ADDENDUM NO. 2

RE: Mobile Harbor Crane at Facility One

FROM: Tina Perkins, Project Administrator
Toledo – Lucas County Port Authority
One Maritime Plaza
Toledo, Ohio 43604-1866
Website: www.toledoport.org
P: (419)243-8251

Question No. 7 - Pictures

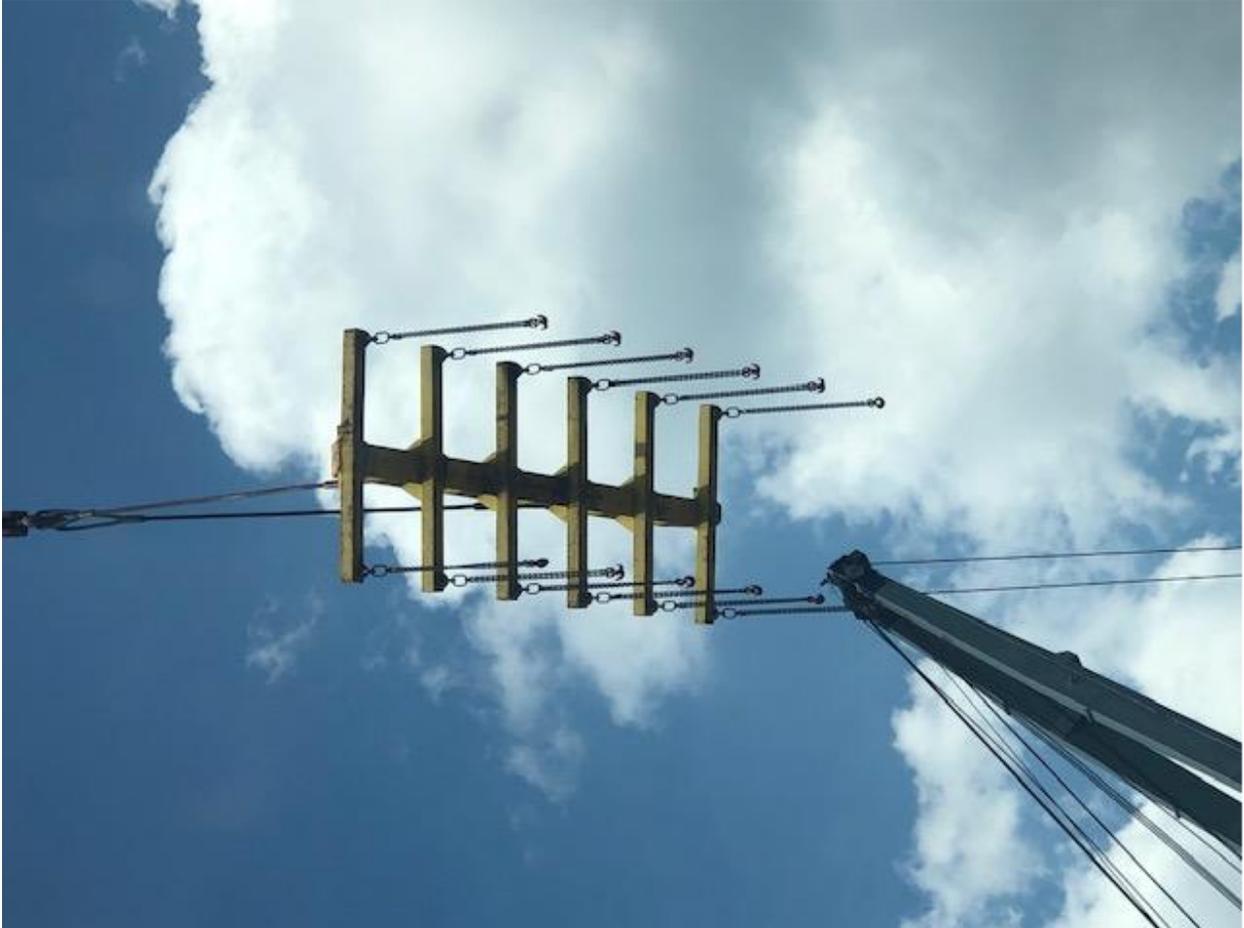
- 7) Question: Possible contradiction in the geometrical requirements of the spreader bar for the super sacks. We understand that 16 super sacks shall be handled with the bar in one row, each sack having a length of 1.25 m. As per our understanding this results in a minimum required spreader bar length of $15 \times 1.25 \text{ m} = 18.75 \text{ m} = 61'-6"$. However, in the tender documents the requirement is a maximum spreader bar length of 30'-4".

Answer: Add 2 more square beams for a total of 8 which will have 2 chains on each with max width of 30'-4". See attached pictures.
